PLAN REVIEW COMMENTS

ALT 235-21

29 Ridge Croft Road

Installation of a new pervious, exterior basketball court

PROPOSED SURVEY SCALE 1:300

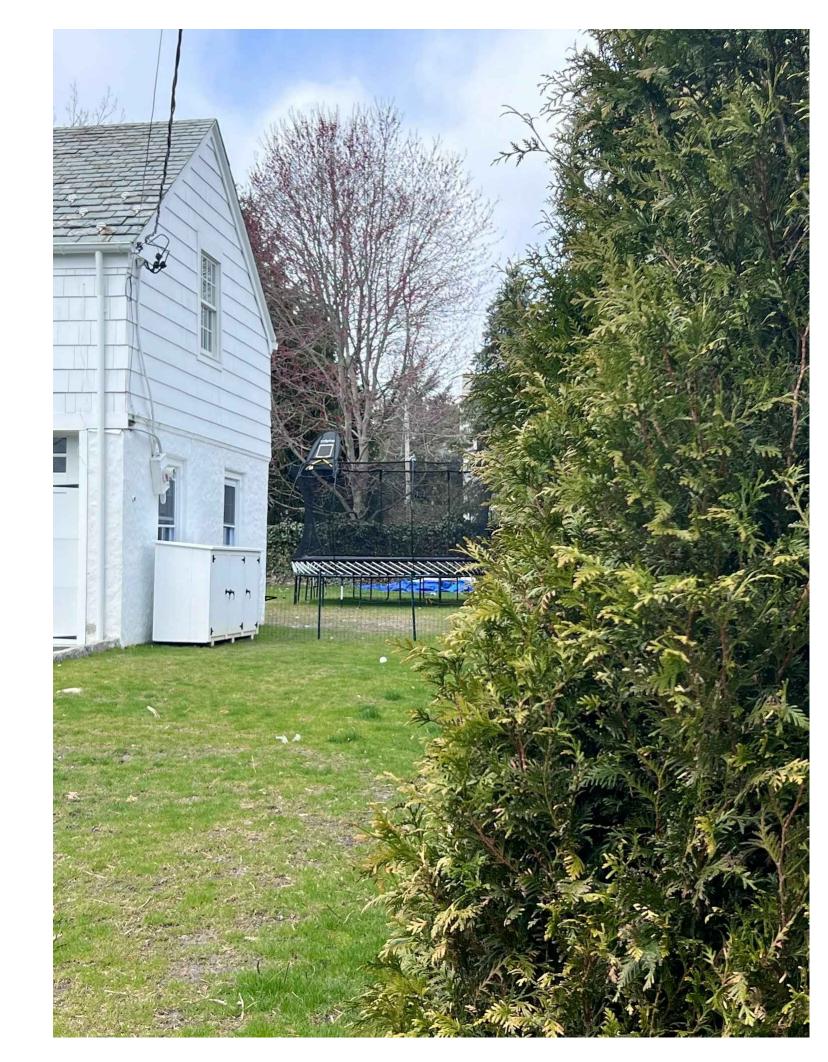
- 1) Building coverage not all items included in calculation, please revise and add stonewall on west side of property, fence, a/c units including slab
- 2) Revise open space re" adding the additional building coverage
- 3) FAR increase?
- 4) It is apparent that this application will be referred to ZBA for building coverage but we need to have the accurate information.
